Service Bulletin No: 71-005
Modification No: INSPECTION

POWER PLANT - GENERAL

DO A CHECK OF THE BATCH NO. OF THE SHOCK MOUNTING BOLTS AND REPLACE, IF NECESSARY

Replacement of the Shock Mount Bolts
Figure 1

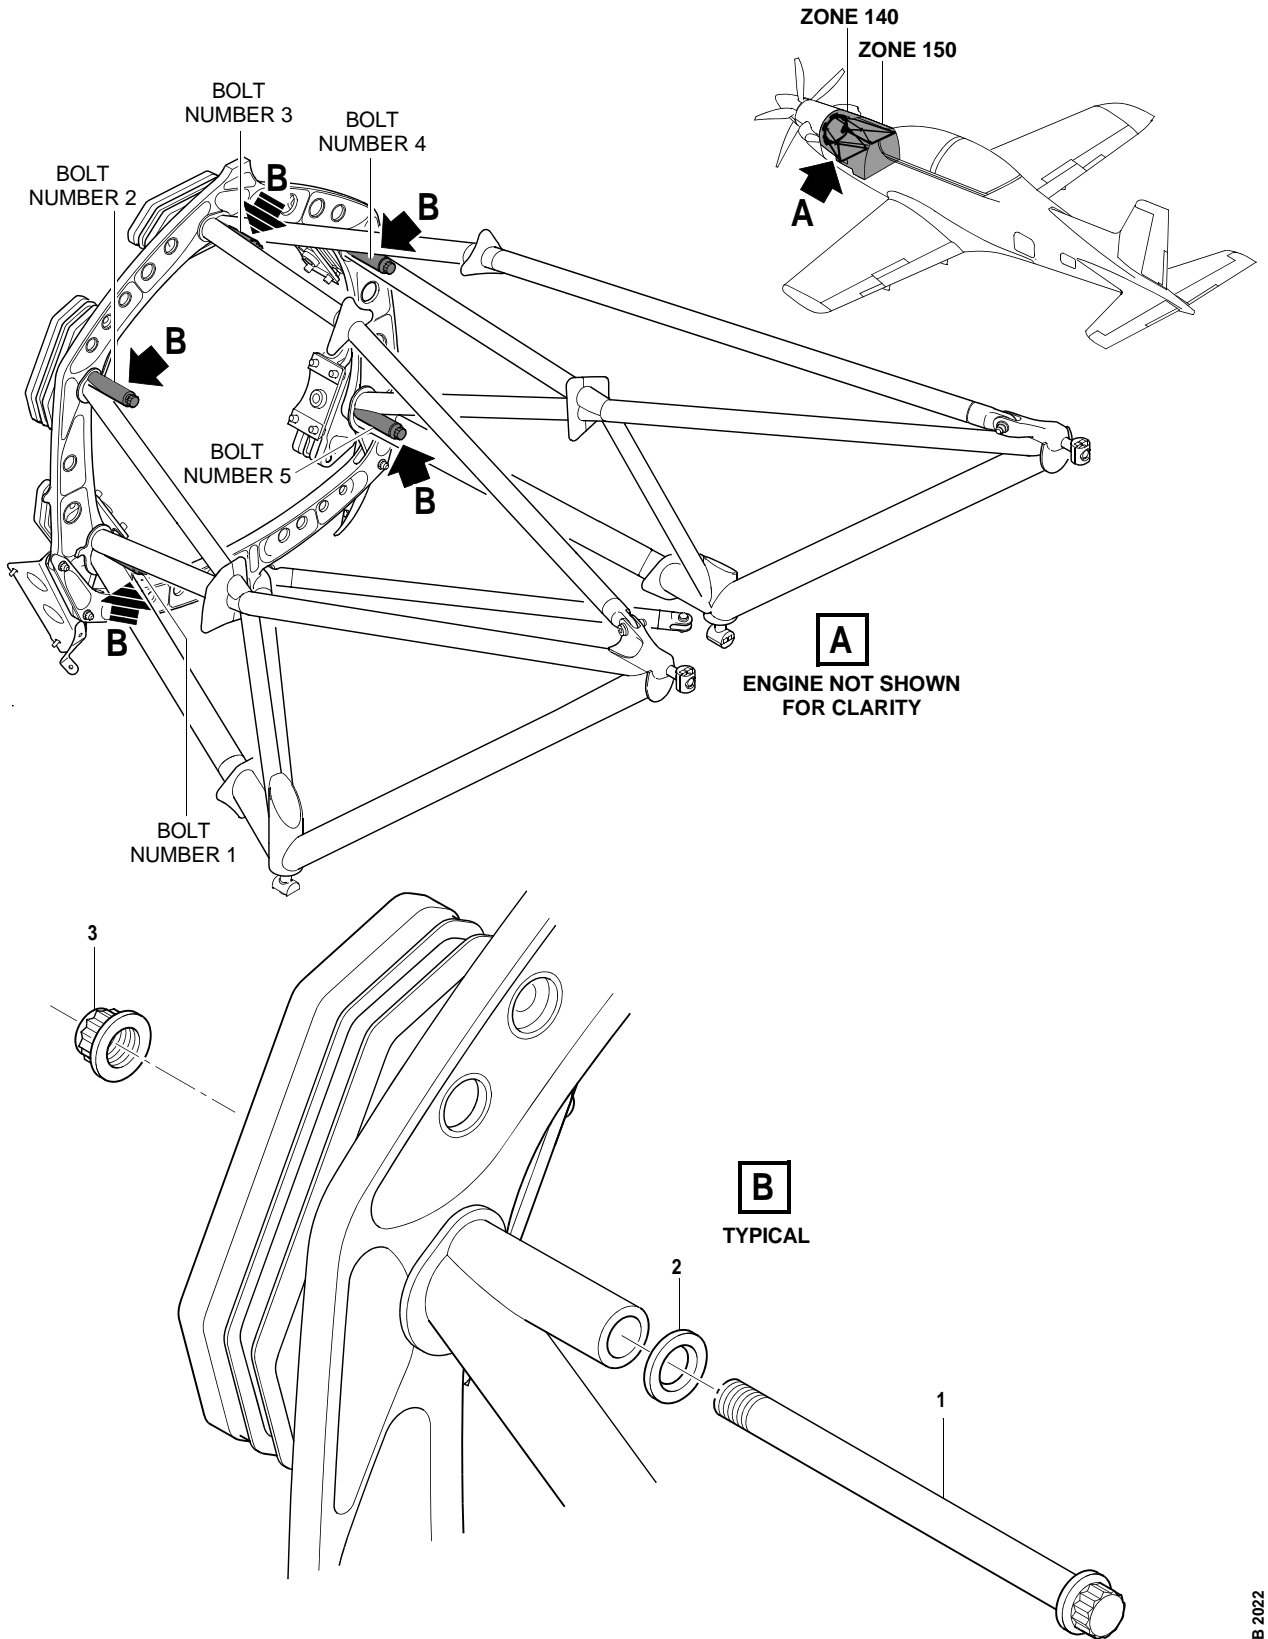
An Operator has reported that during an unscheduled engine removal on one of his aircraft, one of the shock mount bolts (P/N 571.20.21.066) had lost the cadmium plating at some locations. The bolt has been traced to a certain batch and are manufactured with a vacuum plating process.

Replace the shock mount bolts (P/N 571.20.21.066) with bolts from a known good batch.

B. Do An Inspection of the Shock Mount Bolts (Ref. Fig. 1)

Look on the head of each of the five bolts (1).

- (1) If the batch number on the one or more bolts is 415196, continue with the Service Bulletin from Para. 3.C. for the bolts with a batch number of 415196.
- (2) If none of the bolts (1) have the batch number 415196, continue with the Service Bulletin from Para. 3.D(7).

C. Replacement of the Shock Mount Bolts (Ref. Fig. 1)

- (12) Remove an affected bolt number:
 - (a) Remove the nut (3).
 - (b) Remove the bolt (1) and the washer (2).
 - (c) Discard the nut (3) and the washer (2).

- (13) Measure the run-down torque of the new nut and bolt:
 - (a) Get one new nut (3) (P/N 938.09.14.308) and one new bolt (1) (P/N 571.20.21.066).
 - (b) Put the new nut (3) (P/N 938.09.14.308) on the new bolt (1) (P/N 571.20.21.066).

- (i) Install the new nut (3) (P/N 938.09.14.308) with your fingers as far as possible.
- (15) Do Para 3.C.(11) thru (14) for the remaining affected bolts but do not remove more than one bolt (1) at a time.

- (16) Torque the attachment nut:
- (a) Add the run-down torque you noted at Para 3.C.(12)(f) to 92.5 Nm (819 lb.in.).
 - (b) Torque the new nut (3) (P/N 938.09.14.308) to the torque calculated in Para. 3.C.(16)(a) \pm 2.5 Nm (22 lb.in.).
